Category II Propulsion
System Evaluation

SUBJECT: ASD Addendum Report to FTC-TR-71-39

**UH-1N
CATEGORY II PROPULSION
SYSTEM EVALUATION**

TIME HISTORIES OF DUAL-ENGINE TRANSIENTS —
COLLECTIVE PITCH CONTROL

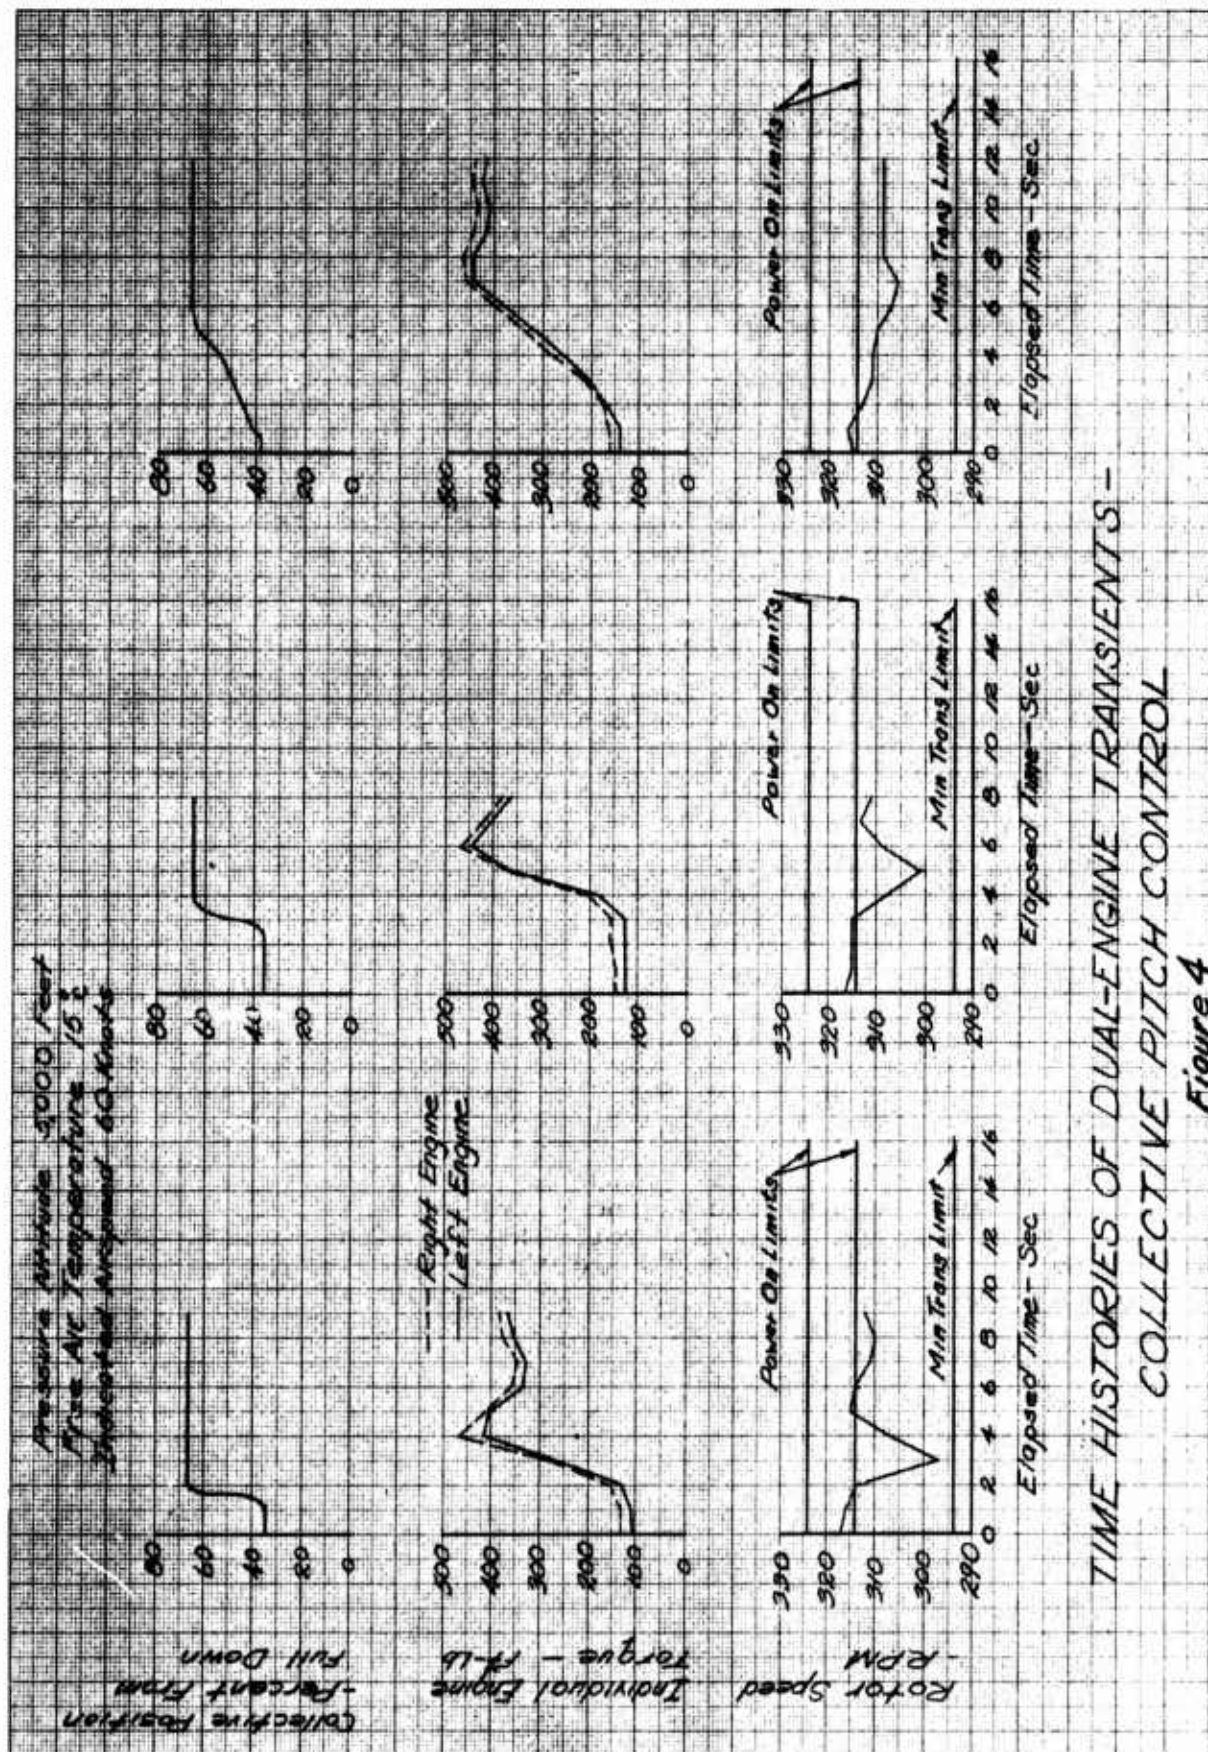
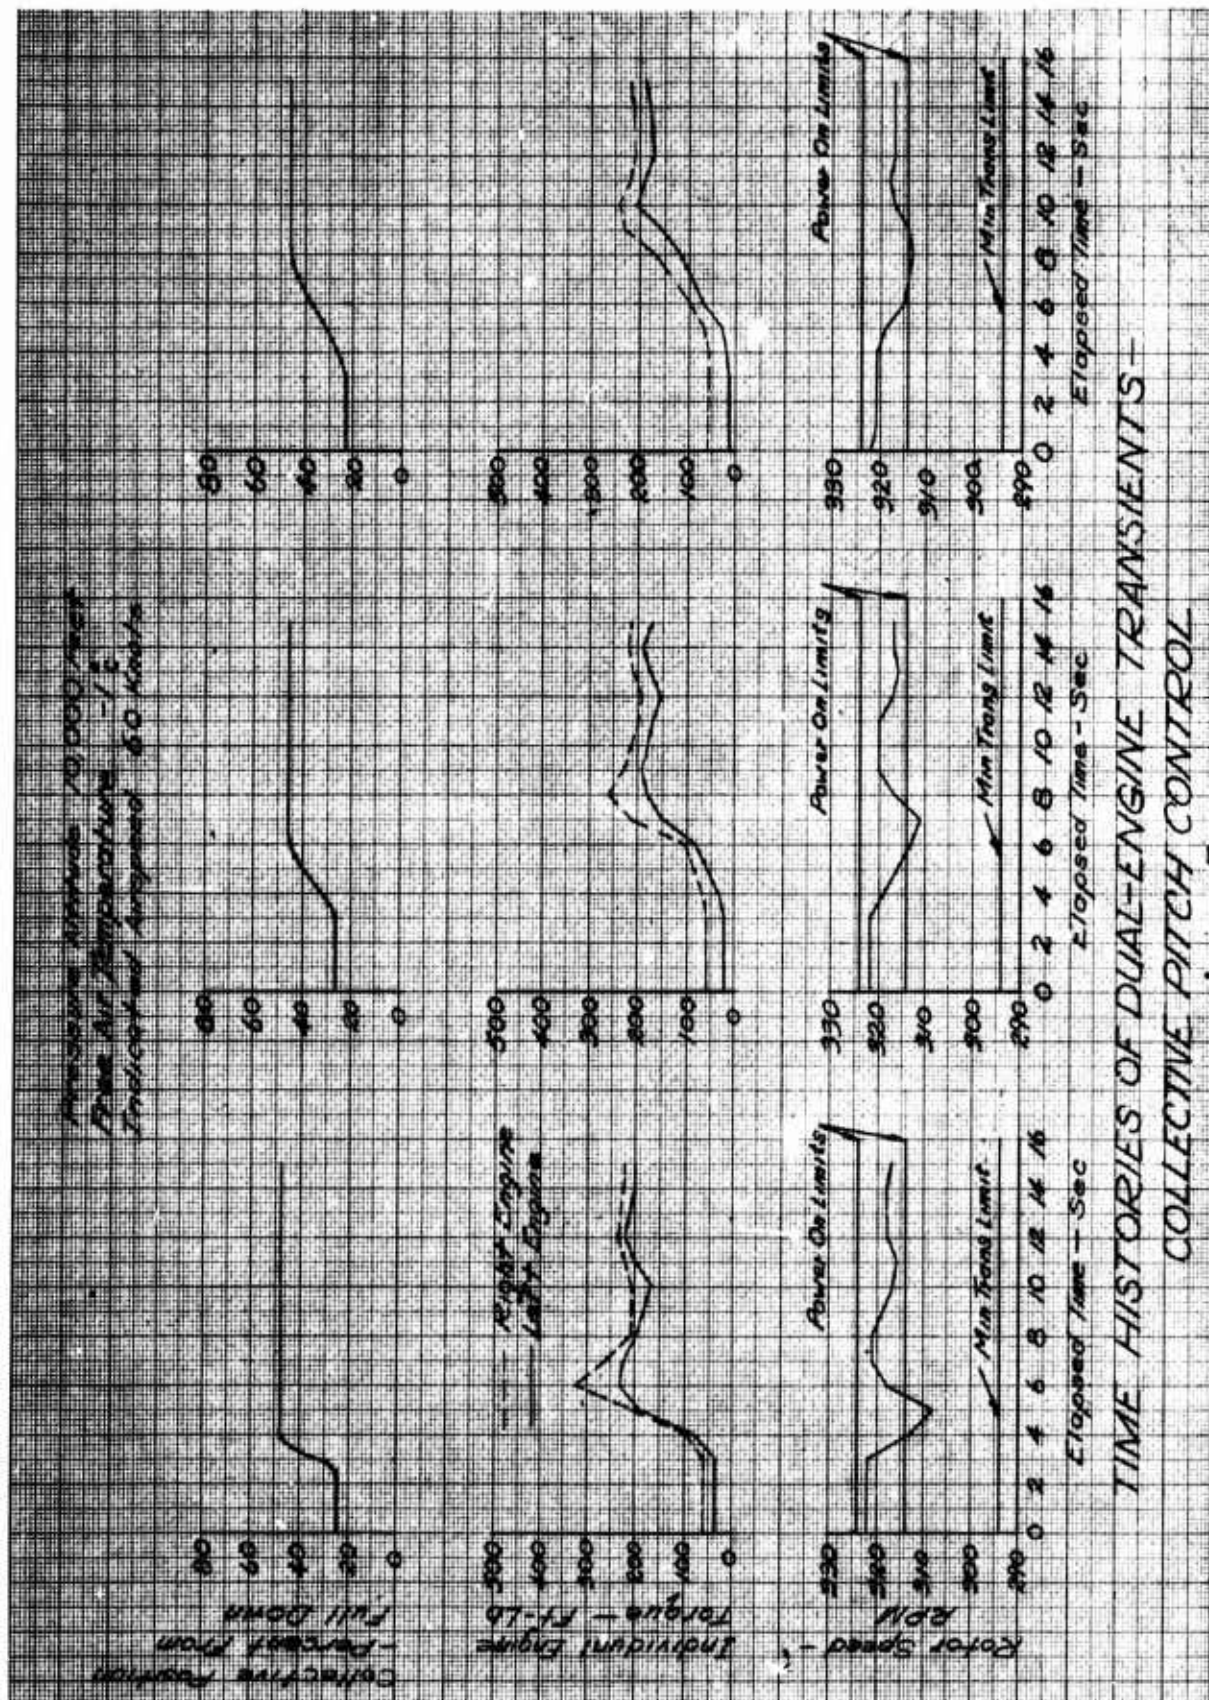
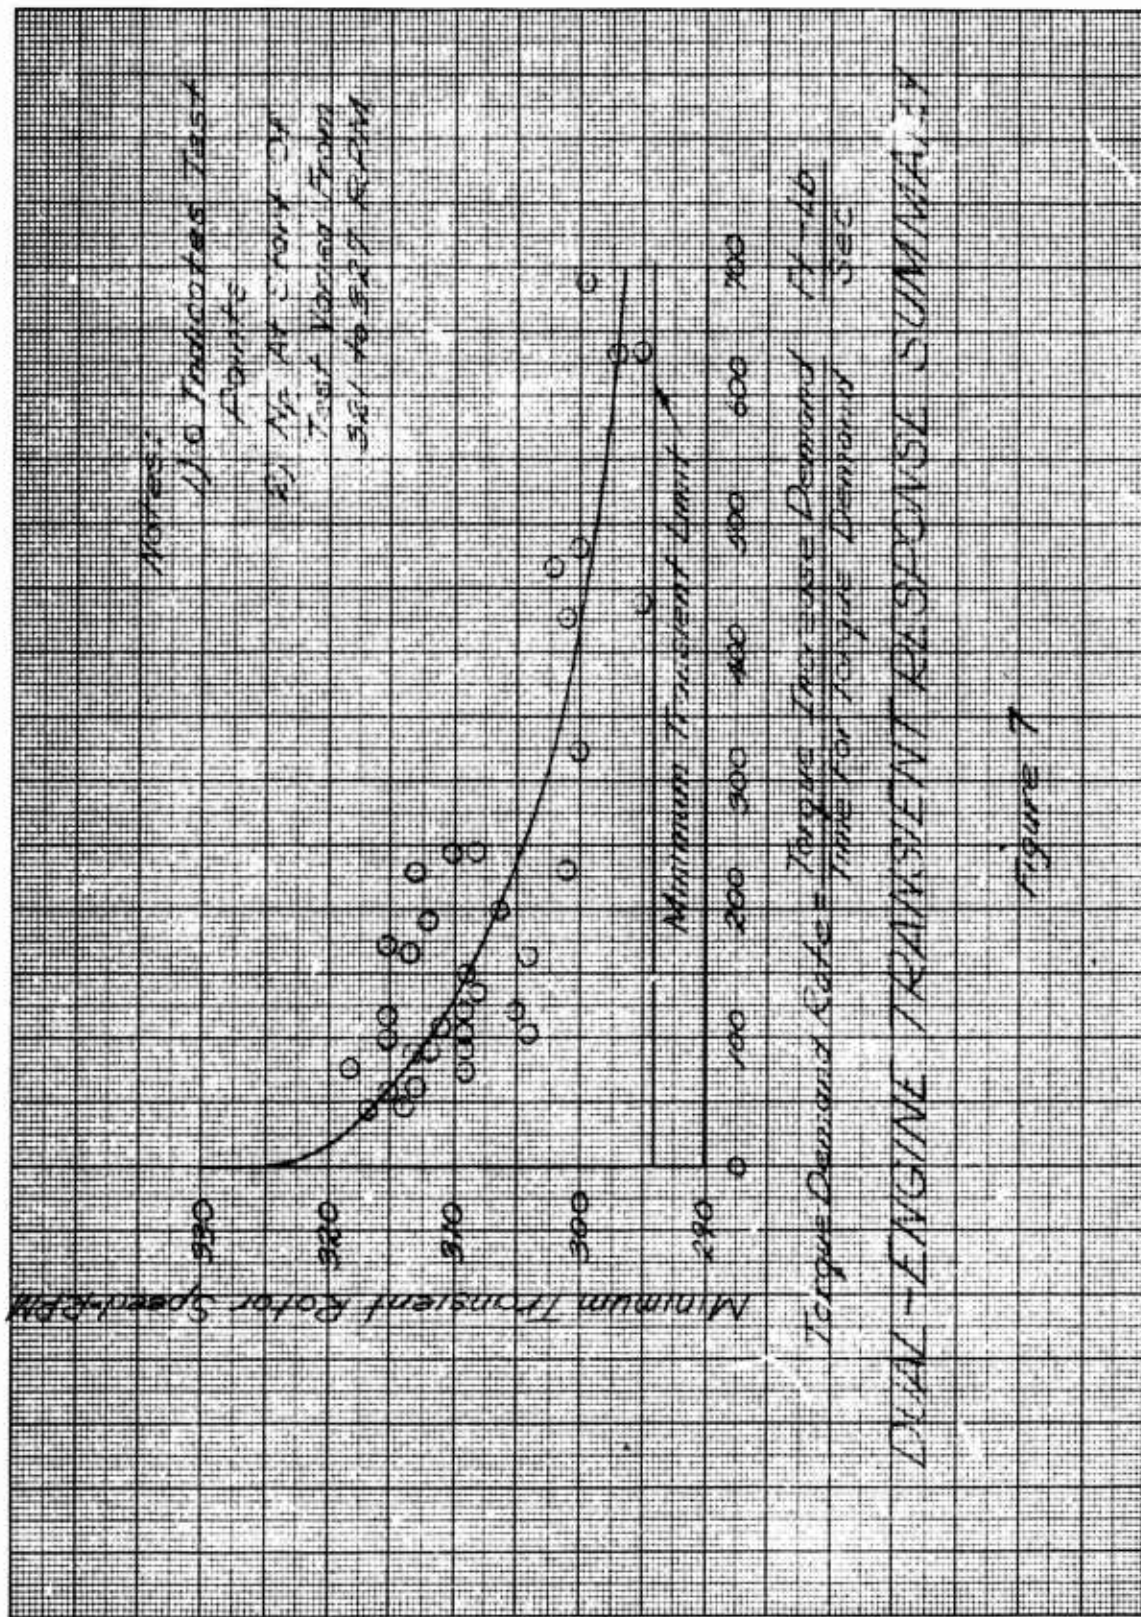
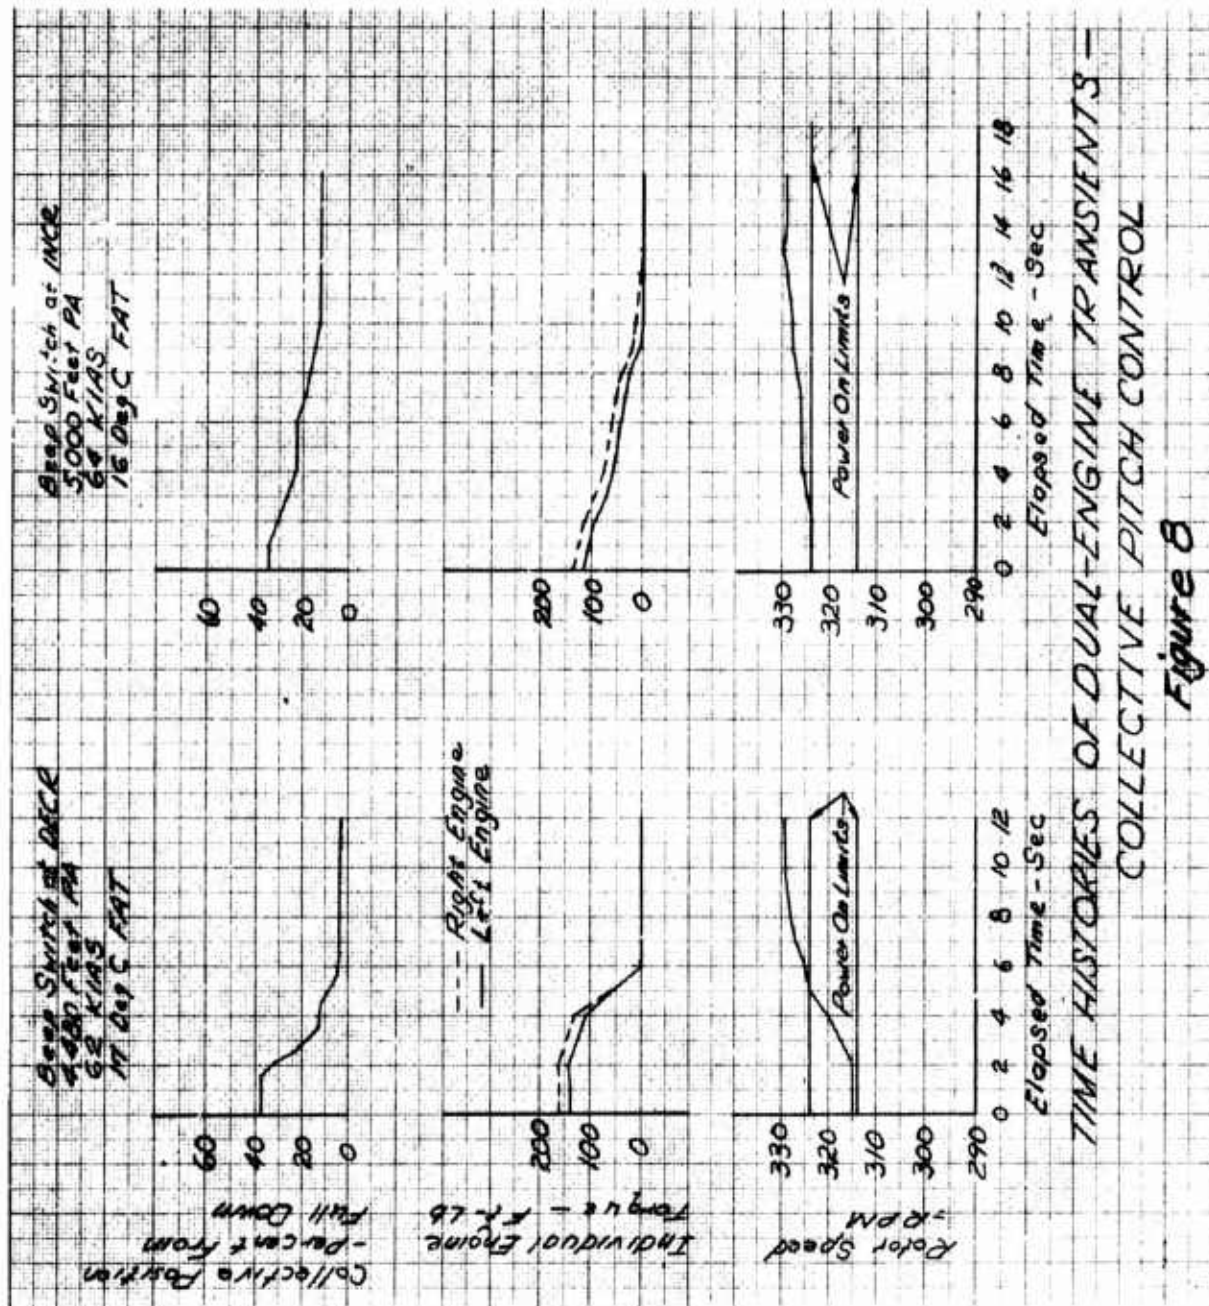
All transients exhibited a characteristic one cycle overshoot in torque and rotor rpm, with the overshoot more pronounced at the highest collective pitch control transients rates. This presented no problem during the testing. However, it was possible that the engines would overtorque if rapid collective pitch control movement to a high setting was attempted. A CAUTION should be added to the Flight Manual stating that this type of collective pitch control movement should be avoided.
(R8)

8. Concur with intent. Abrupt movement of flight controls is prohibited by section V of the flight manual. No further action is planned.
9. Do not concur. Costs associated with the recommended change are not commensurate with the anticipated benefits. Flight manual coverage of this characteristic should suffice. ASD has initiated action to incorporate the required information in the flight manual.
